# Access Compliance Report

## Public Rights-of-Way

Intersection ID: 20047	Main Street: SHARON_RD	Cross Street: MORRISON_BV	Location: W
ADA ID: F18A625490D9	Ramp Type: PerpDiag	Initial Pass/Fail: Fail	Overall Compliance: No
		Severity Score: 22.5

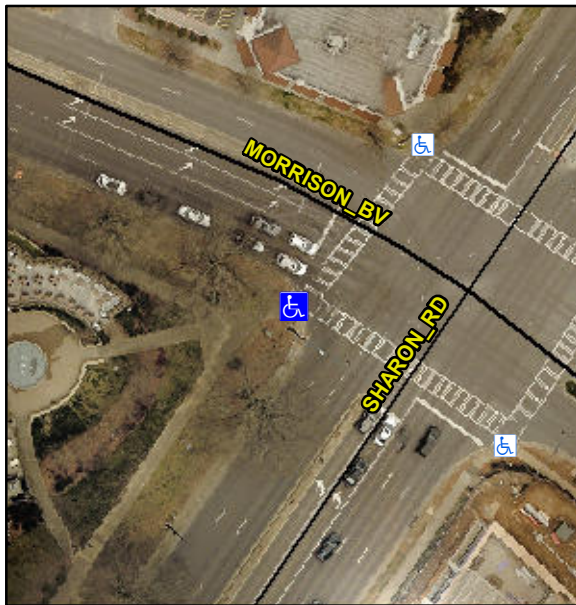
**R304.5.1, R304.2.2, R304.5.3**

Compliance	Description	Data	Compliance	Description	Data
N/A	Ramp Length (in)	89.0	No	Ramp Slope (%)	10.0
No	Ramp Width (in)	45.0	No	Ramp XSlope (%)	4.3
N/A	Flare Type LT	N/A	N/A	Flare Type RT	N/A
N/A	Flare Slope LT (%)	N/A	N/A	Flare Slope RT (%)	N/A
N/A	Flare Traversable LT?	N/A	N/A	Flare Traversable RT?	N/A
N/A	Landing Length (in)	N/A	N/A	DWS Provided?	N/A
N/A	Landing Width (in)	N/A	N/A	DWS Contrast?	N/A
N/A	Landing Slope (%)	N/A	N/A	DWS Length (in)	N/A
N/A	Landing X Slope (%)	N/A	N/A	DWS Full Width?	N/A
N/A	Landing Curb? (Y/N)	N/A	N/A	DWS Offset (in)	N/A
N/A	Shared Landing?	N/A			
N/A	Gutter Ponding?	N/A	N/A	Gutter Slope (%)	N/A
N/A	Gutter Lip Ht (in)	N/A	N/A	Gutter X Slope (%)	N/A
N/A	Painted X Walk1?	Yes	N/A	Painted X Walk2?	Yes
	X Walk 1 Direction	To SE		X Walk 2 Direction	To NE
N/A	X Walk 1 Width (in)	106.0	N/A	X Walk 2 Width (in)	112.0
	X Walk 1 Slope (%)	4.2		X Walk 2 Slope (%)	2.1
	X Walk 1 X Slope (%)	0.3		X Walk 2 X Slope (%)	4.9

**Remove & Replace Curb Ramp With Two New Directional Ramps or Equivalent.**
